Subject: 1385 Hillside Circle - proposed development **Date:** Monday, July 21, 2025 12:42:08 PM

To: Public Comment; Burlingame Planning Dept
Subject: Comment on DSR25-0023, 1385 Hillside Circle
Date: Sunday, September 7, 2025 7:37:55 PM

Lot Subdivision, Major Design Review, Hillside Area Construction Permit and Special Permits at 1385 Hillside Circle - Lot 1 (Project No. DSR24-0023)

1381 Hillside Circle Burlingame, CA 94010 Attachment A: Depiction of what the original plot lines were prior to the existing structure being built.

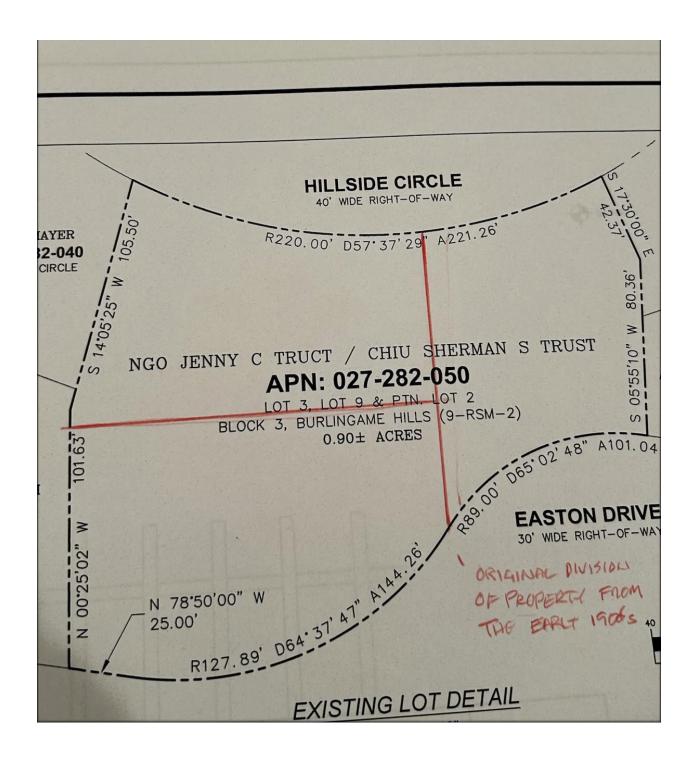
I respectfully request that the **City formally study and address these issues** before any approvals are granted. In particular, I urge serious consideration of the **original parcel map** for the property, which designated **two lots on Hillside Circle and one on Easton**

Drive (Attachment A). This configuration would reduce congestion and mitigate safety concerns.
